Access Compliance Report Public Rights-of-Way (Curb Ramps)

Main Street: MEDFORD_RD Cross Street: SANDHURST_ST Location: NW

ADA ID: RPAT211007124337 Ramp Type: Type 1 - Perpendicular Diagonal Initial Pass/Fail: Fail Overall Compliance: No Severity Score: 30

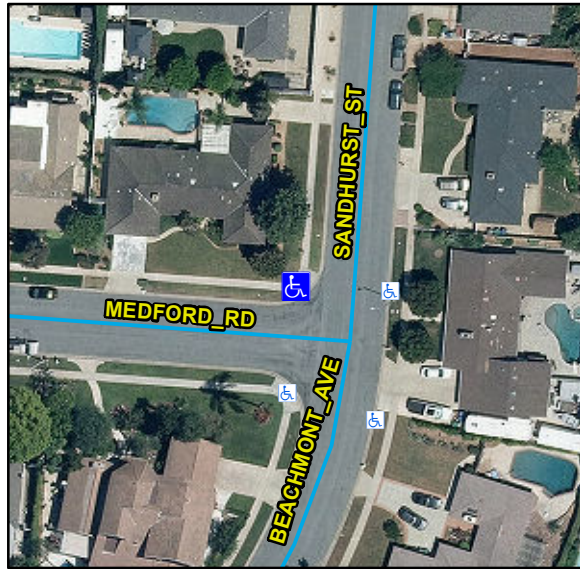
Compliance	Description	Data	Compliance	Description	Data
N/A	Ramp Length (in)	104	N/A	Flare Type LT	
Yes	Ramp Width (in)	52			N/A
No	Ramp Run Slope (%)	9.1	N/A	Flare Slope LT (%)	N/A
No	Ramp Cross Slope (%)	5.5	N/A	Flare Traversable LT	N/A
N/A	Landing Present	N/A	N/A	Flare Type RT	
N/A	Landing Length (in)	N/A			N/A
N/A	Landing Width (in)	N/A	N/A	Flare Slope RT (%)	N/A
N/A	Landing Run Slope (%)	N/A	N/A	Flare Traversable RT	N/A
N/A	Landing Cross Slope (%)	N/A	N/A	DWS Provided	N/A
N/A	Landing Movement Obstructed?	N/A	N/A	DWS Contrast	N/A
	Landing Movement Type	N/A	N/A	DWS Length (in)	N/A
N/A	Landing Shared	N/A	N/A	DWS Full Width	N/A
N/A	Clear Space	Yes	N/A	DWS Offset Left (in)	N/A
N/A	Clear Space To Crosswalk (in)	N/A	N/A	DWS Offset Right (in)	N/A
N/A	Marked Crosswalk 1	No	N/A	Marked Crosswalk 2	No
	Crossing 1 Direction	S		Crossing 2 Direction	E
	Marked Crosswalk 1 Width (in)	N/A		Marked Crosswalk 2 Width (in)	N/A

N/A	Ramp Inside Crosswalk 1	N/A	Yes	Ramp Inside Crosswalk 2	N/A
	Crossing 1 Slope (%)	2.3		Crossing 2 Slope (%)	4.4
	Crossing 1 Cross Slope (%)	2.5		Crossing 2 Cross Slope (%)	1.3
N/A	Gutter Ponding	N/A	No	Curb Slope	7.6
Yes	Gutter Lip Height (in)	0		Road Run Slope (%)	0.9
N/A	Gutter Run Slope (%)	N/A		Road Cross Slope (%)	7.2
N/A	Gutter Cross Slope (%)	N/A			
Yes	Overall Surface Condition: Acceptable		Yes	Perp Joint Present	Yes
	Cross Gutter Present?	No		Spandrel Present?	No
	Replace Cross Gutter?	N/A		Replace Spandrel?	N/A

Remove & Replace Curb Ramp With Two New Directional Ramps or Equivalent.
